State of New Mexico
Energy, Minerals and Natural Resources

WELL API NO. 30-005-63538
5. Indicate Type of Lease STATE <input checked="" type="checkbox"/> FEE <input type="checkbox"/>
6. State Oil & Gas Lease No. VA-2101
7. Lease Name or Unit Agreement Name Miller State
8. Well Number #1
9. OGRID Number 9974
10. Pool name or Wildcat 00800 Acme San Andres Southeast

SUNDRY NOTICES AND REPORTS ON WELLS (DO NOT USE THIS FORM FOR PROPOSALS TO DRILL OR TO DEEPEN OR PLUG BACK TO A DIFFERENT RESERVOIR. USE "APPLICATION FOR PERMIT" (FORM C-101) FOR SUCH PROPOSALS.)	
1. Type of Well: Oil Well <input checked="" type="checkbox"/> Gas Well <input type="checkbox"/> Other <input type="checkbox"/>	
2. Name of Operator Hanson Operating Company, Inc.	
3. Address of Operator P O Box 1515, Roswell, NM 88202-1515	
4. Well Location Unit Letter <u>N</u> : <u>1200</u> feet from the <u>South</u> line and <u>1980</u> feet from the <u>West</u> line Section <u>2</u> Township <u>8 South</u> Range <u>27 East</u> NMPM Chaves County	
11. Elevation (Show whether DR, RKB, RT, GR, etc.) 3929' GR

Propose to Plug and Abandon the well as follows:

AFTER

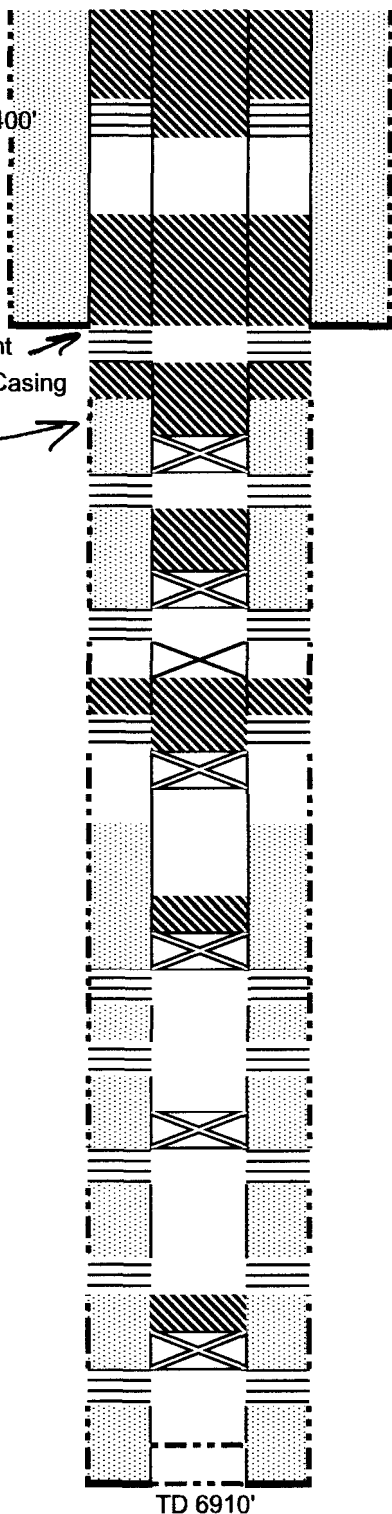
Approved for plugging of well bore only.
Liability under bond is retained pending receipt
of C-103 (Subsequent Report of Well Plugging)
which may be found at OCD Web Page under
Forms. www.cmnrd.state.nm.us/oed.

WELL MUST BE PLUGGED BY 10/12/2018

★ SEE ATTACHED COA-S

1. Set CIBP at 2000' with 35' cement cap. → WOE & TAG
2. Perf 4 squeeze holes at 645'
3. Pump 25 sacks cement for 100' plug inside and outside 5 1/2" casing from 645' to 545'
4. Wait on cement for 4 hours. Tag cement.
5. Perf 4 squeeze holes at 400'.
6. Pump 100 sacks cement for 400' plug inside and outside 5 1/2" casing to surface.
